**4. Rezoning Application No. 00614 for 3103 Washington Avenue**

## Committee of the Whole Report For the Meeting of January 11, 2018

**Subject:** Rezoning Application No. 00614 for 3103 Washington Avenue

Title:  
EXIST. &  
PROPOSED SITE  
PLAN

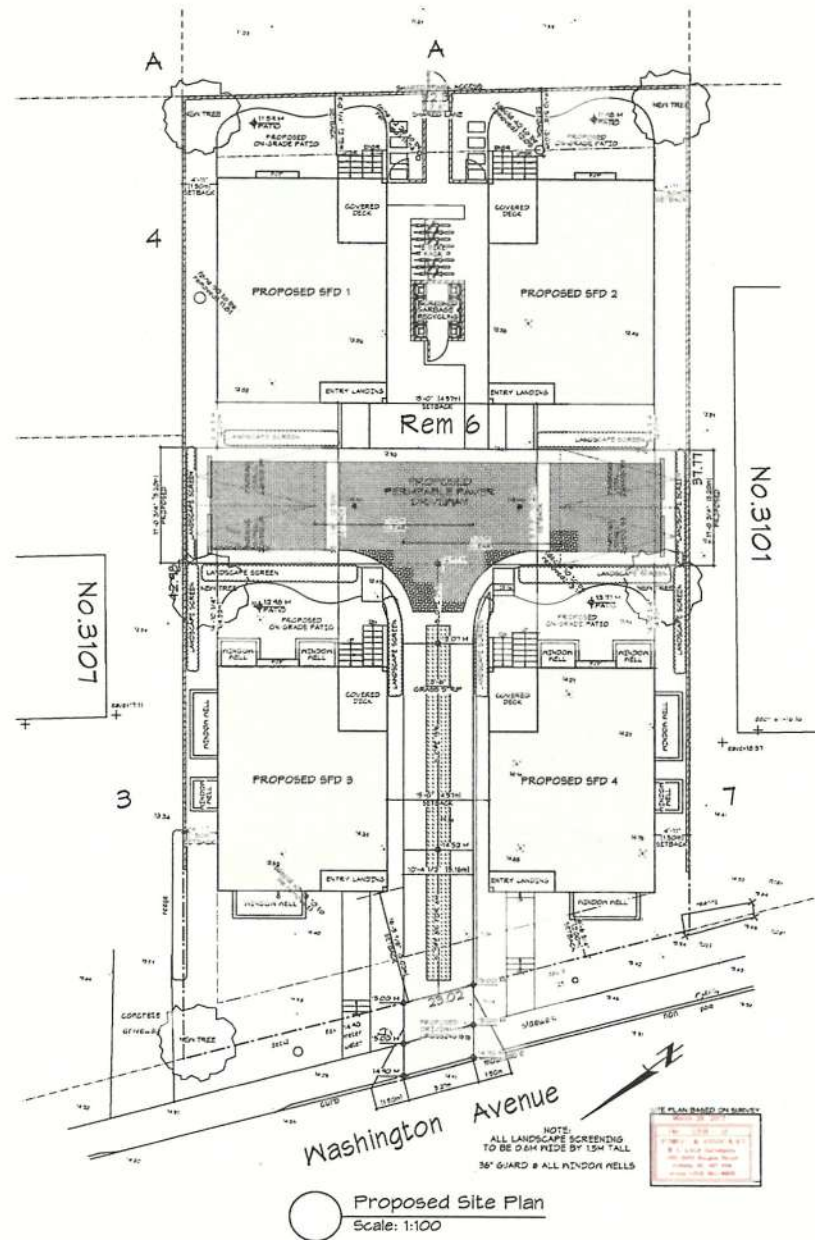
- be a good neighbour to adjacent homes, with massing mitigating impacts on neighbours
- present a friendly face, with units adjacent to the street and other public spaces
- encourage street vitality and social interaction amongst neighbours, with useable semi-private space or front porches along streets
- ensure livability and considerations for outdoor space
- contribute positively to the unique character and identity of the neighbourhood
- desired separation distance between buildings for this lot is approximately 24ft.

The proposal complies with the policies relating to the streetscape appearance, social interaction, family-oriented housing, private outdoor space, landscaped front and rear yards, and separation distance between buildings (exceed 24ft); however, staff have concerns with the proposed site planning, the number of buildings on the lot and the amount of site area dedicated to vehicles. This proposed site layout may be more suitable if the subject property had two frontages.

The proposal is compared to the R-K Zone; based on this comparison the proposal exceeds the minimum open site space requirement, and the site coverage is only 0.23% more than the maximum permitted in the zone (which is 33%). The existing site area and lot width are 899.41m<sup>2</sup> and 22.30m, respectively; whereas, the minimum site area and lot width requirements in the R-K Zone are 555m<sup>2</sup> and 18m, respectively. In comparison to the small lot zones, the minimum lot area for a small lot is 260m<sup>2</sup>; whereas, in this proposal the lot area per dwelling unit is 224.85m<sup>2</sup>.

We are proposing to add a grass strip down the driveway and in accordance with the suggestion of Development Services staff, to remove the fifth parking stall. This will further increase our green space on site - additional plantings will be implemented - and also allow us to address the requirement for garbage and recycling locations (please refer to the updated site and landscape plans for details).
